COPYRIGHT @ 1993 AT&T ALL RIGHTS RESERVED	
BT13	
5ESS SWITCHING EQUIPMENT DETAIL CHANGE SPECIFICATION FOR FIELD CONVERSION MATERIAL	
DWG SIZE C2	ISSUE 4
AT&T	ED5D670-30
SHEET A1 OF 12

1.1.1 ED5D670-30 IS A CLASS B CHANGE ISSUED TO PROVIDE THE MEANS TO
*** CONTINUED ***

REPLACE HARD-WIRED FAN UNIT ALARM BOARDS WITH CONNECTORIZED ALARM BOARDS. ED5D670-30 PROVIDES THE EQUIPMENT, WIRING AND CABLING REQUIRED FOR 1 TO 5 SM FAN UNIT, (FU), ALARM BOARD REPLACEMENT(S).

METHOD OF ROUTING FAN MULT CABLES
FIG. 2

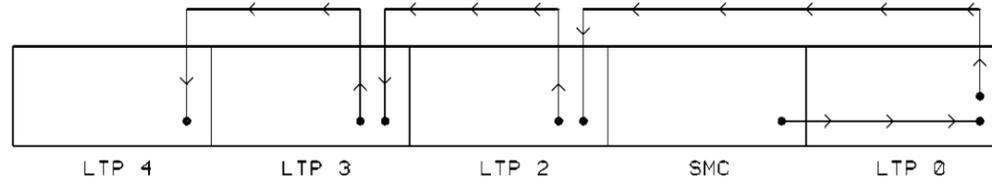
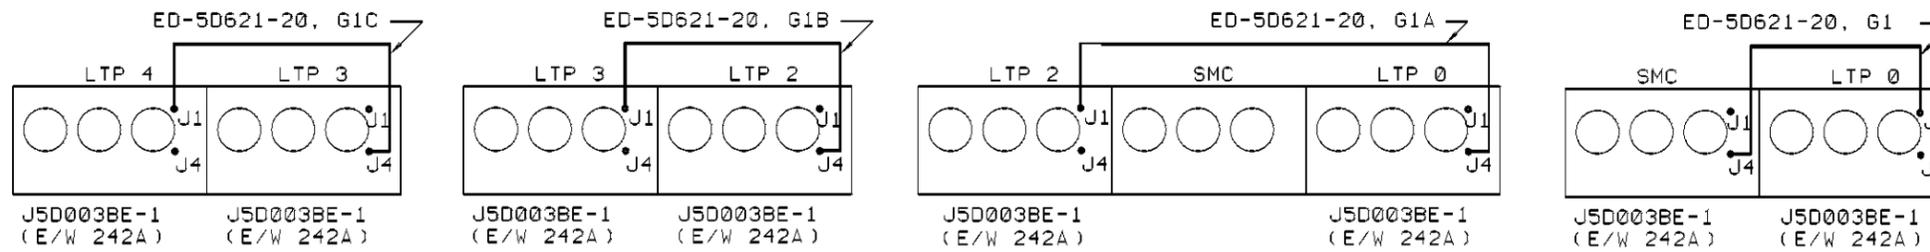
- WHEN ASSIGNING FAN MULT CABLES - START WITH
1. SMC TO LTP 0
 2. LTP 0 TO LTP 2
 3. LTP 2 TO LTP 3
 4. LTP 3 TO LTP 4

3.2.4 REMOVE THE INTER-CABINET ALARM MULT CABLE(S) FROM THE SUBJECT CABINET TO THE PRECEDING (IF EQUIPPED) AND TO THE SUCCEEDING (IF EQUIPPED). REFER TO FIGURE 2 FOR THE GENERAL LAYOUT OF THE ALARM MULTIPLE CABLES. IF BOTH ENDS OF THE AFFECTED CABLE(S) ARE HARD-WIRED, REFER TO TABLE AN FOR THE APPROPRIATE WIRING REMOVALS. IF ONE END OF THE AFFECTED CABLE(S) IS CONNECTORIZED, REFER TO TABLE AR FOR THE APPROPRIATE WIRING REMOVALS. (SEE ALSO FIGURE 4 OR 5).

HARD WIRED 3-FAN TO CONNECTORIZED 3-FAN
CABLE ARRANGEMENT
FIG. 4

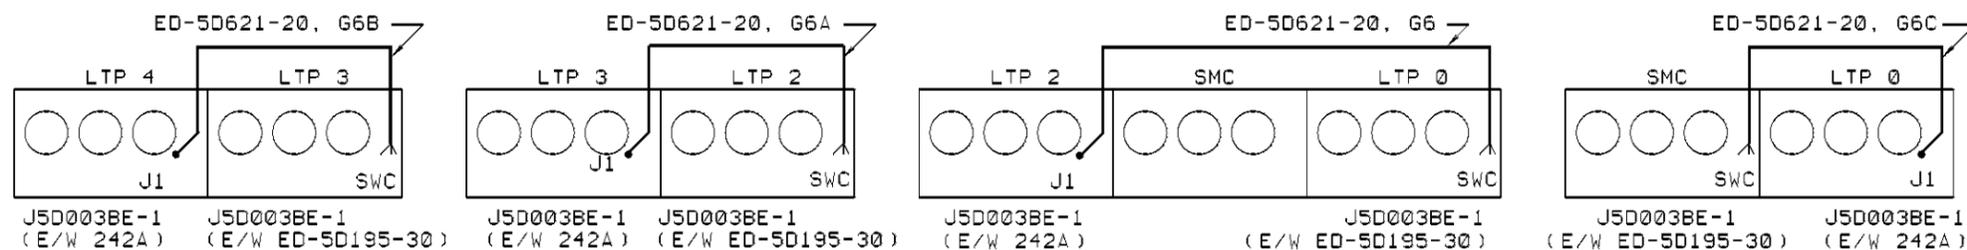
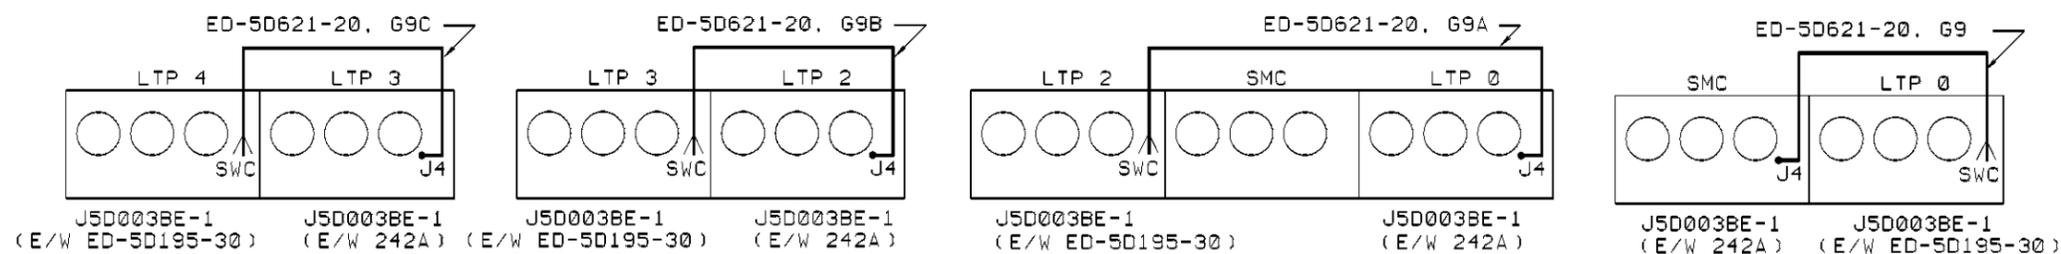
INFORMATION. THE FOLLOWING ALARM MULT CABLING TABLE MAY BE OF SOME HELP FOR DETERMINING THE CORRECT CABLES TO USE. IN ADDITION, FIGURES 3,4 AND 5 SHOULD BE REFERRED TO FOR ADDITIONAL CABLING INFORMATION. REFER TO FIGURE A FOR TERMINAL LOCATION ON THE CONNECTORIZED ALARM BOARD. INSTALL AND CONNECT THE ALARM MULT CABLES PER THE ABOVE INFORMATION.

FIG. A

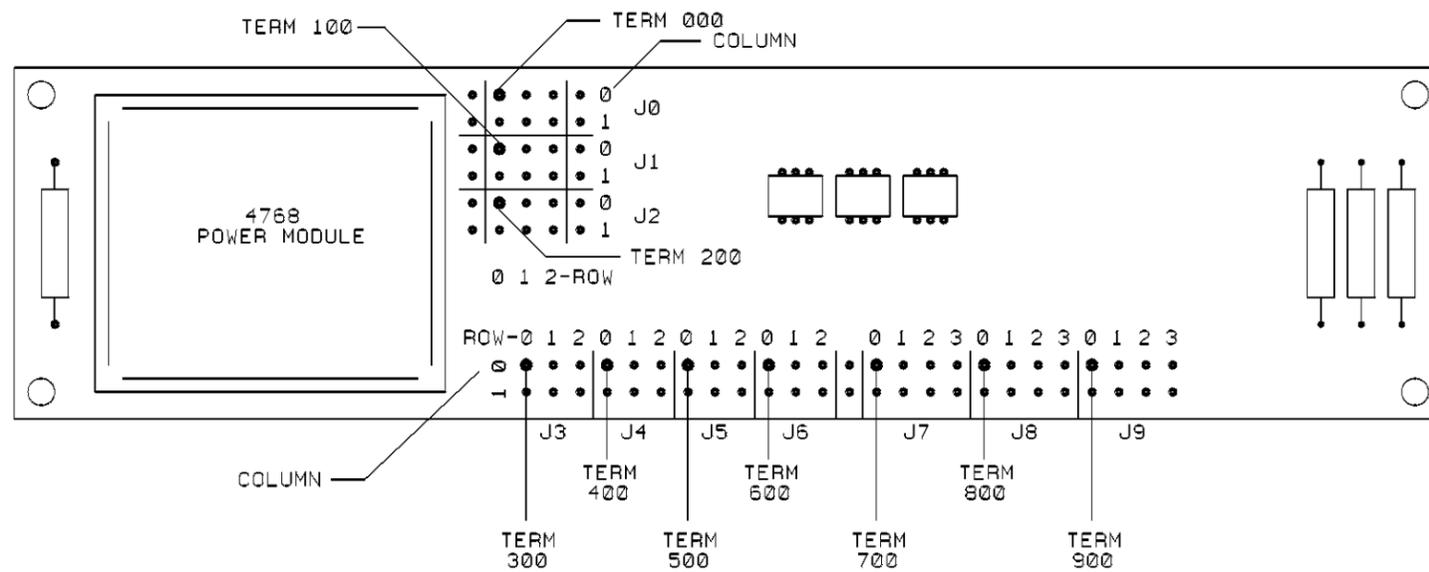
3.2.7.2 AT THE CONNECTORIZED ALARM BOARD, CONNECT THE CABLE COMING FROM THE OUT-OF-SERVICE MCTU SIDE AS SHOWN IN TABLE AM (G6A= SIDE 0, G6B= SIDE 1). ALSO REFER TO FIGURE A FOR TERMINAL LOCATION ON THE CONNECTORIZED ALARM BOARD.

3.2.8 CONTINUE WITH THE CABINET LED CABLE CONNECTION. AT THE CONNECTORIZED ALARM BOARD, CONNECT THE LED CABLE PER TABLE AK (ALSO SEE FIGURE A FOR TERMINAL LOCATION ON THE ALARM BOARD).

3.2.9 CONTINUE WITH THE FAN UNIT TERMINAL BLOCK (TBLK) TO ALARM BOARD CONNECTIONS. AT THE CONNECTORIZED ALARM BOARD, CONNECT THE CABLES COMING FROM THE FAN TBLKS PER TABLE AJ. ALSO REFER TO FIGURE A FOR TERMINAL LOCATION ON THE CONNECTORIZED ALARM BOARD.

FIG. C

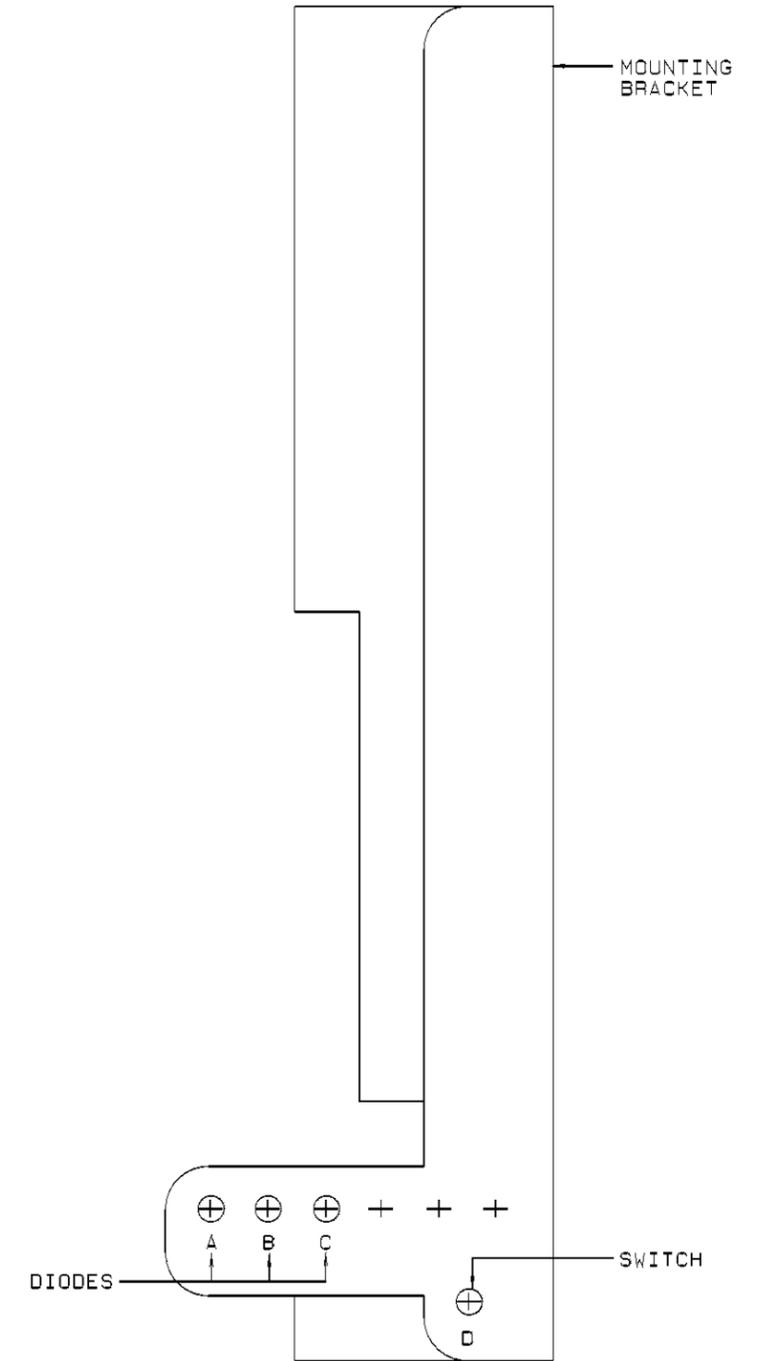
3.1.6.5 AT A SUITABLE WORK AREA, INSTALL THE TWO STRAPS AND CABLE REQUIRED ON THE NEW ALARM BOARD PRIOR TO MOUNTING. FOR THIS WORK SEE THE INFORMATION PROVIDED IN FIGURES B & C AND IN TABLES AG & AH IN ED5D670-30.

3.2.6 VERIFY THAT ALL WIRING TO THE HARD-WIRED ALARM BOARD HAS BEEN REMOVED. REMOVE THE MOUNTING BRACKET AND ALARM BOARD. CAREFULLY INSTALL THE NEW ALARM BOARD WITH ITS BRACKET. THE WIRING FROM THE SOCKETS AND SWITCH ON THE MOUNTING BRACKET TO THE ALARM BOARD SHOULD HAVE BEEN COMPLETED EARLIER (SEE 3.1.6.5).
